Access Compliance Report

Public Rights-of-Way

(Curb Ramps)

Intersection ID: 2606	Main Street: CROWNVISTA_DR	Cross Street: FAIRVISTA_DR	Location: S
ADA ID: 8368D9C4FF05	Ramp Type: PerpDiag	Initial Pass/Fail: Fail	Overall Compliance: No
Severity Score: 21.25			
Codes/Mitigation Info/Possible Solution		Field Measurements/Component Compliance

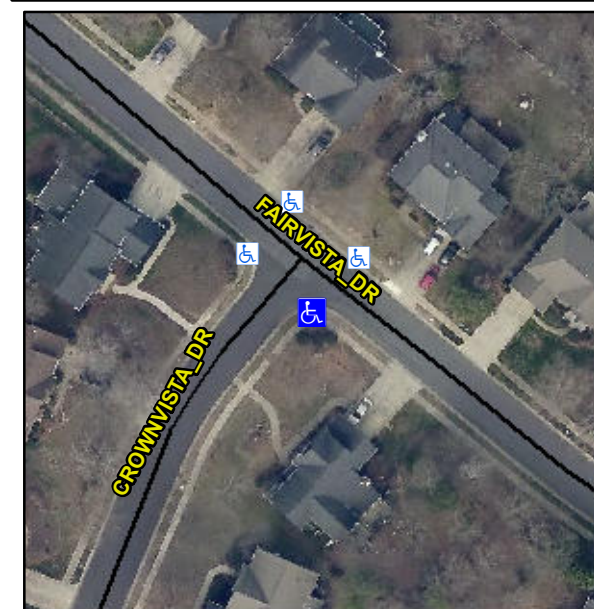
Not Found, R304.5.1, R304.2.2

Compliance	Description	Data	Compliance	Description	Data
N/A	Ramp Length (in)	49.0	No	Ramp Slope (%)	10.4
No	Ramp Width (in)	41.0	Yes	Ramp XSlope (%)	1.4
N/A	Flare Type LT	N/A	N/A	Flare Type RT	N/A
N/A	Flare Slope LT (%)	N/A	N/A	Flare Slope RT (%)	N/A
N/A	Flare Traversable LT?	N/A	N/A	Flare Traversable RT?	N/A
N/A	Landing Length (in)	N/A	N/A	DWS Provided?	N/A
N/A	Landing Width (in)	N/A	N/A	DWS Contrast?	N/A
N/A	Landing Slope (%)	N/A	N/A	DWS Length (in)	N/A
N/A	Landing X Slope (%)	N/A	N/A	DWS Full Width?	N/A
N/A	Landing Curb? (Y/N)	N/A	N/A	DWS Offset (in)	N/A
N/A	Shared Landing?	N/A			
N/A	Gutter Ponding?	N/A	N/A	Gutter Slope (%)	N/A
N/A	Gutter Lip Ht (in)	N/A	N/A	Gutter X Slope (%)	N/A
N/A	Painted X Walk1?	No	N/A	Painted X Walk2?	No
	X Walk 1 Direction	To NE		X Walk 2 Direction	To NW
N/A	X Walk 1 Width (in)	N/A	N/A	X Walk 2 Width (in)	N/A
	X Walk 1 Slope (%)	2.1		X Walk 2 Slope (%)	1.9
	X Walk 1 X Slope (%)	2.0		X Walk 2 X Slope (%)	0.5

Remove & Replace Curb Ramp With Two New Directional Ramps or Equivalent.
